C. AMENDMENT TO DRAWING FIGURES

D. REMARKS

FIG. 5

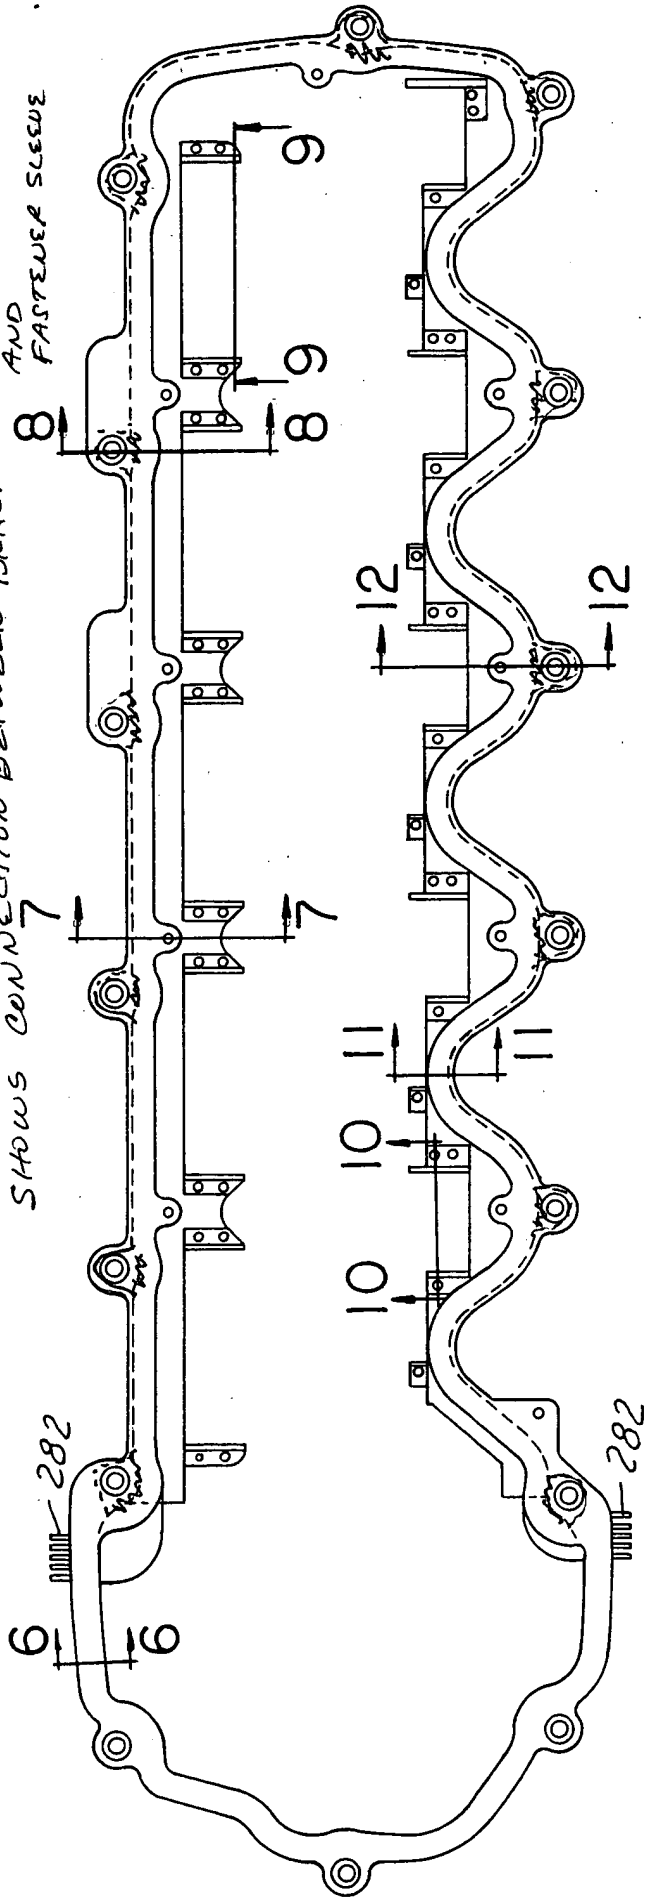
Figures 5, 8 and 12 have been amended to clearly show a connection between the bracket frame 222 and the fastener sleeve 270. This change is supported by originally filed claims 22-23 and 32. Annotated marked-up drawing sheets are attached to this amendment. Approval of the proposed amendment to the drawing is respectfully requested.

SHOWS CONNECTION BETWEEN BRACKET FRAME AND FASTENER SLEEVE
